DELEGATED OFFICER REPORT

WOKINGHAM
BOROUGH COUNCIL

Application Number:	251217
Site Address:	15 Fairview Avenue, Earley, Wokingham, RG6 1HE
Expiry Date:	17 July 2025
Site Visit Date:	29 May 2025
Proposal: Householder application for the proposed erection of a loft conversion with a new roof line including a side dormer and a single storey rear extension with new fenestration and the demolition of existing conservatories.

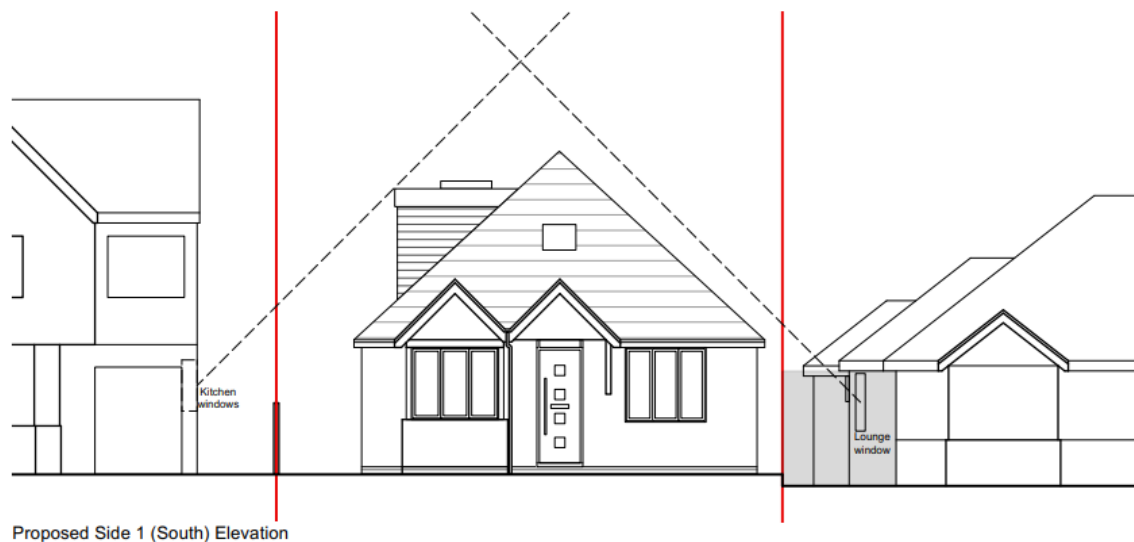
Loss of Light: 11 Fairview Avenue has a ground floor kitchen side window and 17 Fairview Avenue has a ground floor lounge side window and there is concern there would be loss of light to these habitable rooms.

The kitchen window at no.11, is opposite the existing house and therefore any impact would be from the new pitched roof and dormer, which can be seen on the plan below. For the lounge window at number 17, there is already a conservatory opposite this window and the proposed extension will have the same external building line, therefore the only alteration to the existing building affecting these properties would be the new roof pitch.

For the initial consideration of windows opposite a proposed new extension, the British Research Establishment (BRE) Daylight and Sunlight Analysis guide advocates a 25-degree angle rule of thumb test. The angle is less than 25 degrees which is unlikely to substantially affect the diffuse daylight enjoyed by the existing building (see below plan 2514-P201 Rev P1). Therefore, it's considered the proposal would not result in significant loss of light to the neighbouring habitable rooms.
